Appendices

Appendix A	Public Input Summary
Appendix B	Swedesford Road Emergency Access Evaluation
Appendix C	Engineer's Conceptual Opinion of Cost
Appendix D	Valley Creek Bridge Evaluation
Appendix E	Little Valley Creek Bridge Evaluation
Appendix F	Warner Spur Trail FAQ

Public Comment Disclaimer

Warner Spur Multi-Use Trail Master Plan | Community Workshop | 4/3/19

Existing Features (1 of 3)

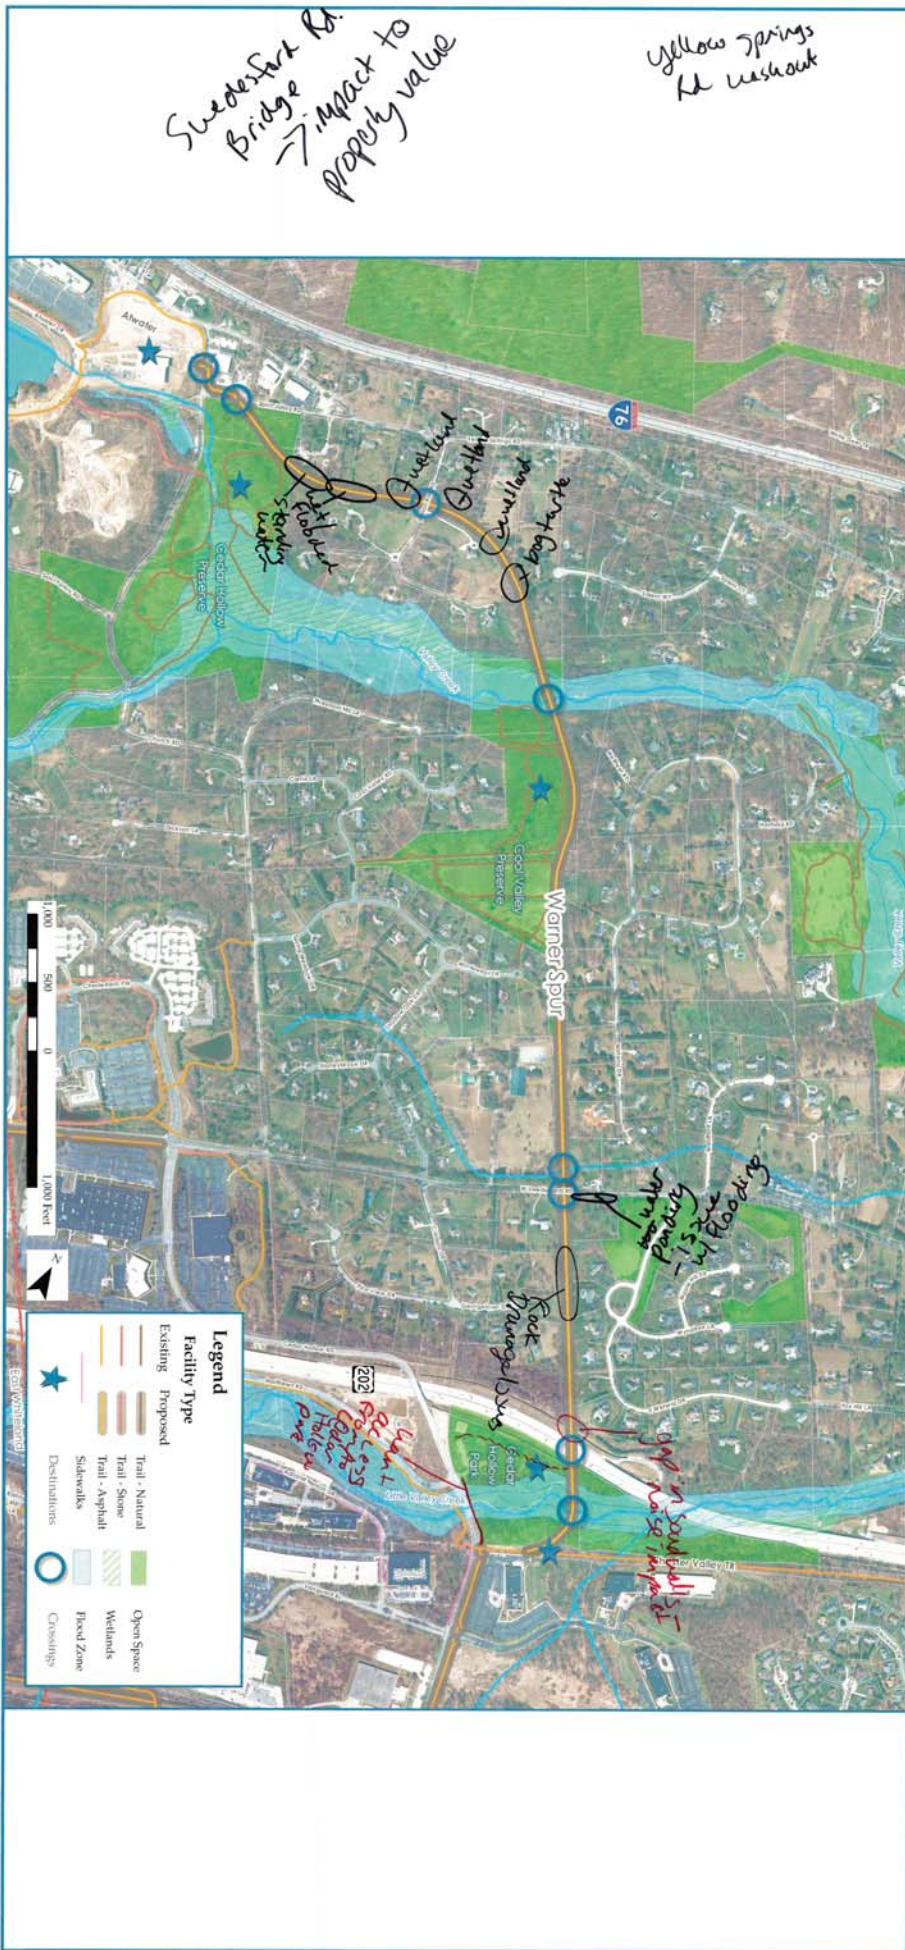
Sweatfork Rd. Bridge
 → impact to property value

Yellow Springs Rd washout

* Security
 * Privacy + Crime

↓
 for lower density
 → Vegetation may be a solution

Maintenance during the winter

Trail surface
 * - concern of stormwater runoff parcels → want

Indian Run trail, loitering → question about ownership

Liability
 - Signage to keep users on trail
 - private road
 - not a trailhead

* Concern about wildlife environment + crossings
 → valued
 Deer,

Environmental impact -
 how do local folks
 perceive v. screens/walls?

bridge v. flat grade
 Sweated is very busy -
 safety of care v. bike etc

people that
 live along trail
 will have to
 pay for trail
 presence on
 parcel / pay
 for trails
 on parcel

CONSIDER
 "NO FORMAL
 FUNDING"
 OPTION
 RAILS TO TRAILS:
 LOWER SEYMOUR
 COUNTY PID THIS

22 SALOM WAY
 WANTS SOME
 TRACK PART
 FROM ROAD
 GRANGES+++
 NO BARBER

22 SUEMMA WAY
 NO FENCE WAY

Existing Features (2 of 3)

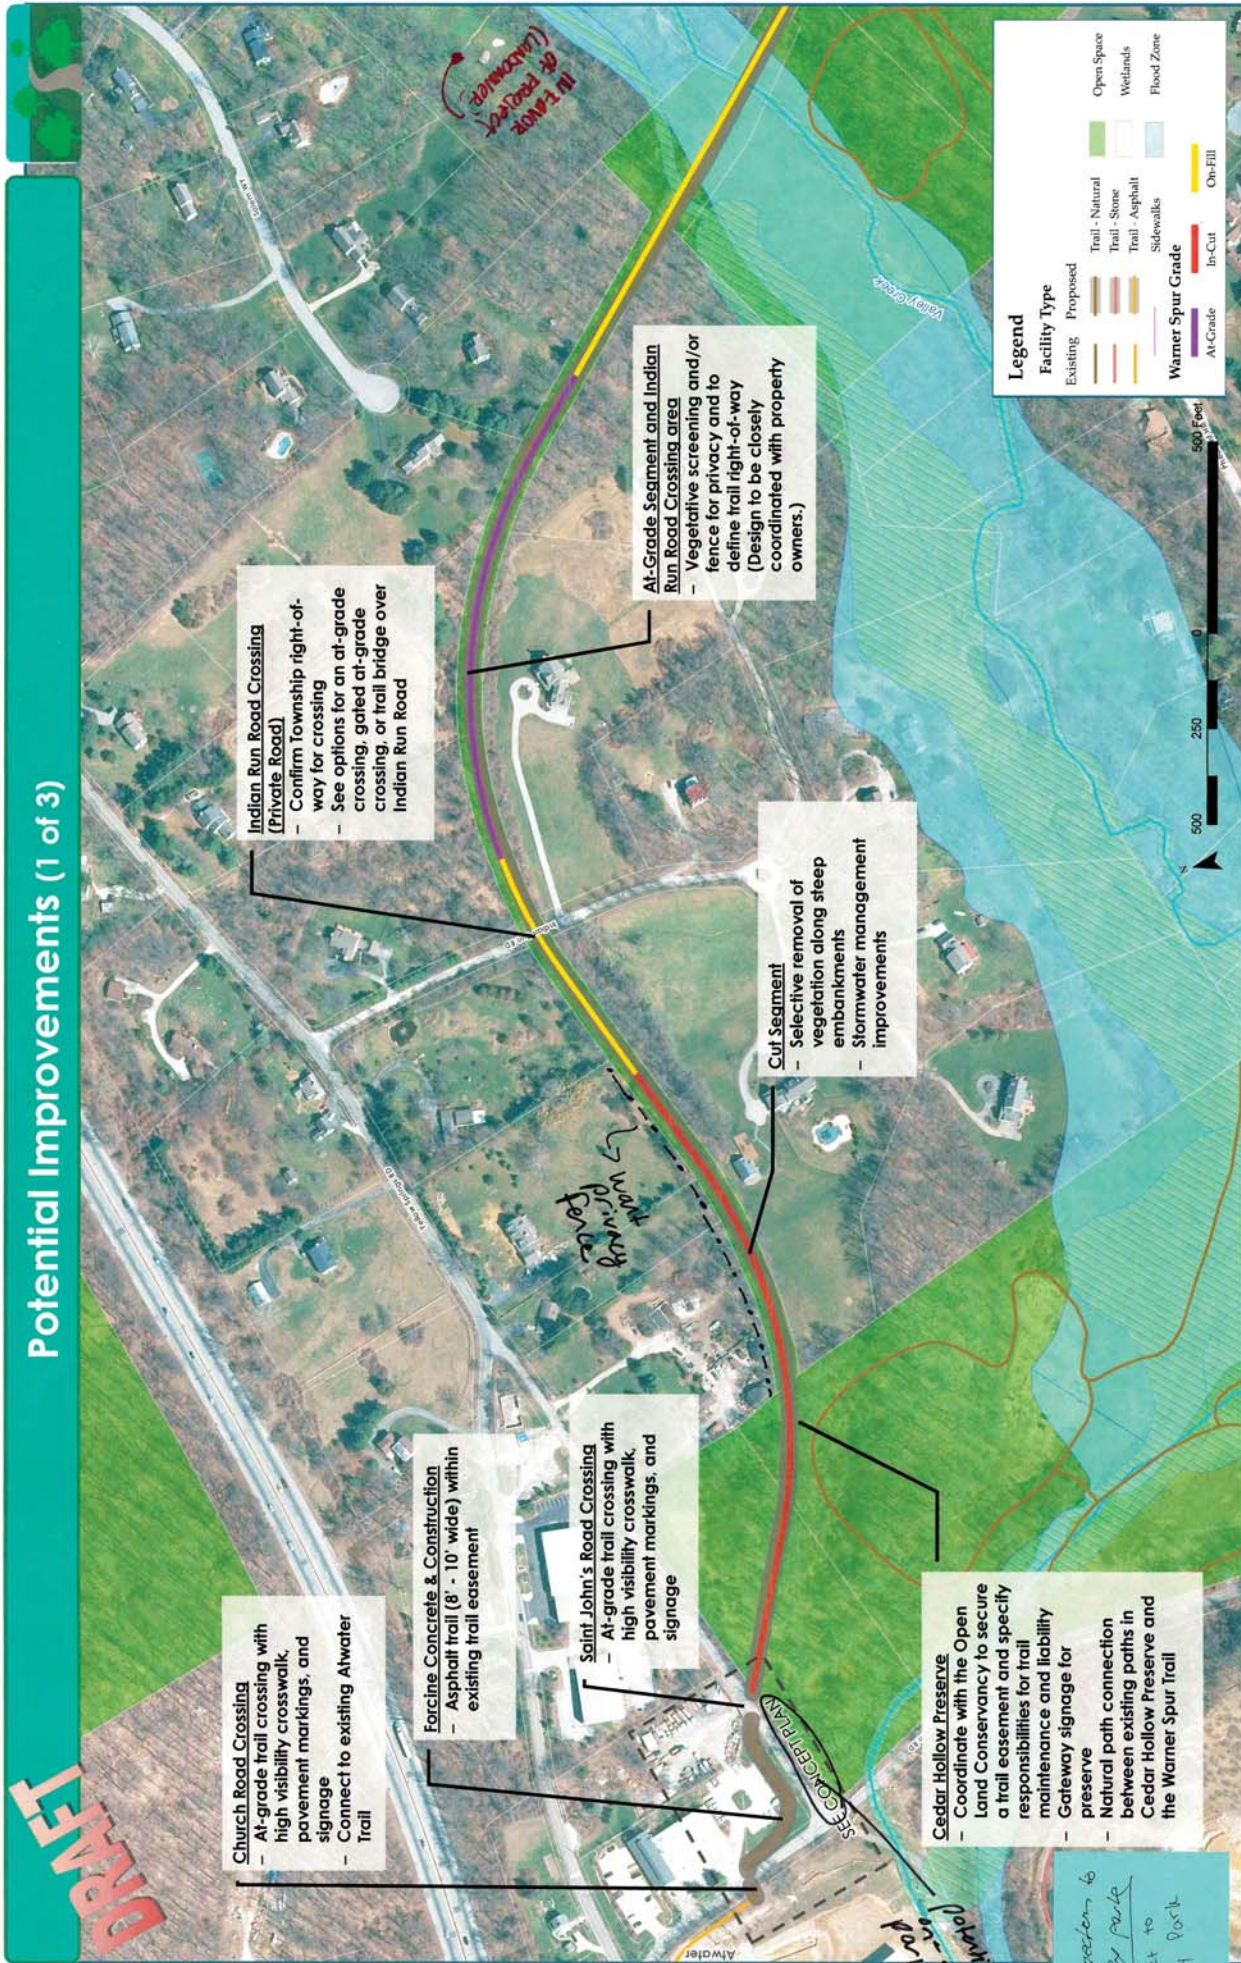
- EMERGENCY ACCESS?

* PARKING CONCERNS

EXTEND SOUND WALL
↳ EXHIB D.
